Technical Review

To:	Danielle Ter Huurne	Date:	29/06/2023
Authority:	Otago Regional Council	Ref:	23009.6
Consent:	RM23.474 Hawkeswood Mining Limited		
From	Role in Audit	Internal Reviewer	
Alexandra Badenhop	Hydrogeology, Water Quality	Simon Bloomberg

Hawkeswood Mining Limited are seeking a range of consents associated with an alluvial gold mining activity at 1346-1536 Teviot Road, Millers Flat, including construction of a bore (the mine pit), dewatering and discharge to land for a seven year term. The water take is described as a non-consumptive take.

Figure 6.1 Potential Extent of Maximum Transient Drawdown External to the Mining Area

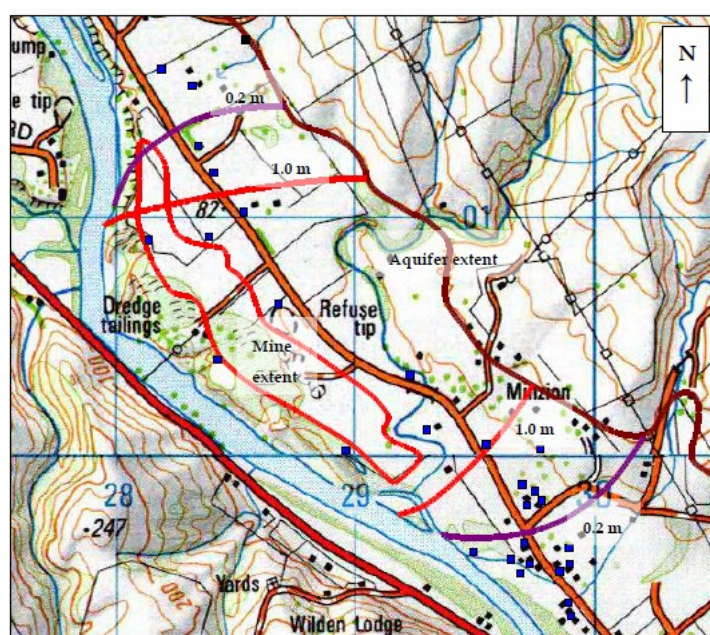
The provided map of saturated thickness indicates that the aquifer is very thin adjacent to Teviot Road, however the mapped aquifer used to assess the likely drawdown (below) is shown to extend to the break in slope 1 km to the east of Teviot Road. The limited aquifer boundary will provide a barrier boundary to flow that will result in increased drawdown as a result of the mining activity (note that this may also result in less water needing to be pumped which would offset the additional drawdown). The barrier boundary was not included in the assessment of drawdown.
